Access Compliance Report Public Rights-of-Way (Curb Ramps)

Main Street: HEWES_AVE Cross Street: BIKINI_PL Location: NE

ADA ID: RPAT211015084909 Ramp Type: Type 4 - Parallel Initial Pass/Fail: Fail Overall Compliance: No Severity Score: 19

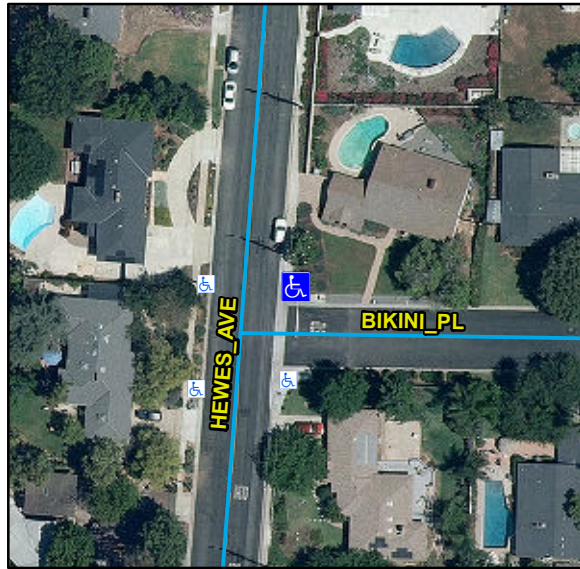
Compliance	Description	Data	Compliance	Description	Data
N/A	Ramp Length LT (in)	116	N/A	Ramp Length RT (in)	73
Yes	Ramp Width LT (in)	48	No	Ramp Width RT (in)	47
No	Ramp Run Slope LT (%)	8.4	Yes	Ramp Run Slope RT (%)	5.7
Yes	Ramp Cross Slope LT (%)	0.5	Yes	Ramp Cross Slope RT (%)	0.9
N/A	Landing Present	N/A	N/A	DWS Provided	N/A
N/A	Landing Length (in)	N/A	N/A	DWS Contrast	N/A
N/A	Landing Width (in)	N/A	N/A	DWS Length (in)	N/A
N/A	Landing Run Slope (%)	N/A	N/A	DWS Full Width	N/A
N/A	Landing Cross Slope (%)	N/A		DWS Offset Type	N/A
N/A	Landing Movement Obstructed?	N/A	N/A	DWS Offset Left (in)	N/A
	Landing Movement Type	N/A	N/A	DWS Offset Right (in)	N/A
N/A	Landing Shared	N/A			
N/A	Clear Space	Yes			
N/A	Clear Space To Crosswalk (in)	N/A			
N/A	Marked Crosswalk 1	No	N/A	Marked Crosswalk 2	No
	Crossing 1 Direction	W		Crossing 2 Direction	S
	Marked Crosswalk 1 Width (in)	N/A		Marked Crosswalk 2 Width (in)	N/A

Remove & Replace Curb Ramp With Two New Directional Ramps or Equivalent.
